## RESPONSE TO AUDIT ISSUES

### APR1400 Topical Reports

Review Section	TR Realistic Evaluation Methodology for LBLOCA of the APR1400
Application Section	Topical Report: APR1400-F-A-TR-12004 Realistic Evaluation Methodology for Large-Break LOCA of the APR1400
Issue Date	08/13/2015

### **Audit Issues No. 27-d**

Figure 1. Mass Flow Rate at Hot Channel Exit – Original Calculation

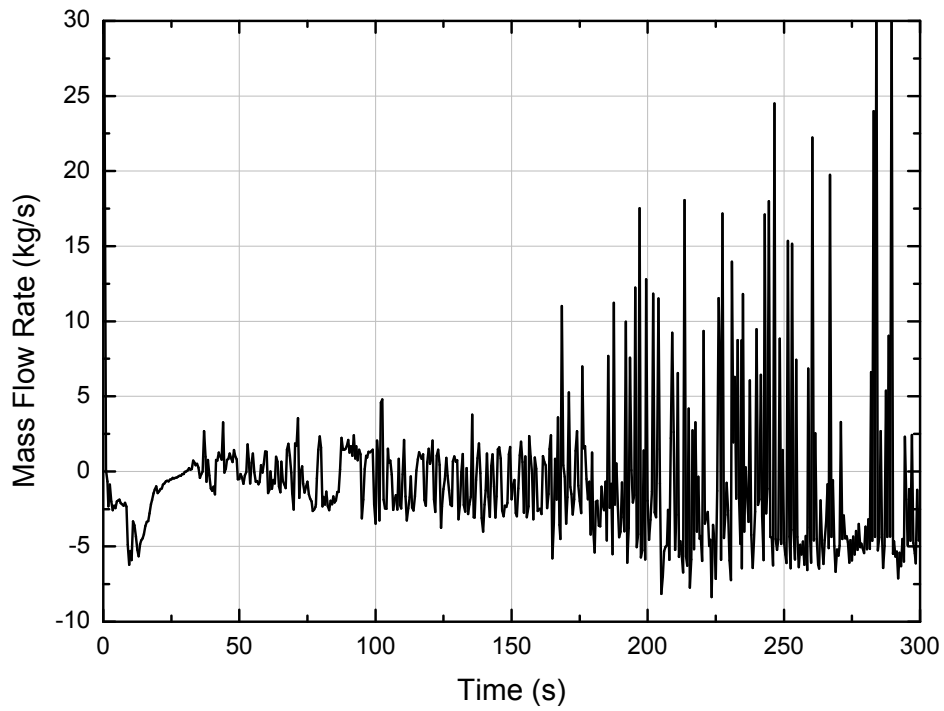
TS The lower power peripheral fuel assemblies are also not represented separately. It is unclear how this nodalization was selected over other options and how it can model multidimensional phenomena (e.g., "upper plenum to core counter-current flows (CCF)" in topical report Table 3-2). Provide the basis for the selected nodalization with respect to capturing the multidimensional phenomena occurring in the core.

Figure 1 shows the mass flow rate at the hot channel exit and it can be seen that some down flow occurs during reflood period. In order to confirm the effect of the down flow, sensitivity calculation was performed by limiting the down flow. For the limitation of the down flow, the reverse K-factor of the junction connecting the hot channel exit and upper plenum was assumed to be very large value. Figure 2 through 4 compare the mass flow rate at the core exit, heat transfer mode and cladding surface temperature at the PCT node respectively. During the reflood period, the heat transfer mode is film boiling until core quench. During film boiling period, heat transfer between wall and liquid is very low because the liquid does not contact directly to the wall. Therefore, even though there is some down flow at the upper region of the hot channel, it does not affect the cladding temperature as shown in Figure 4.
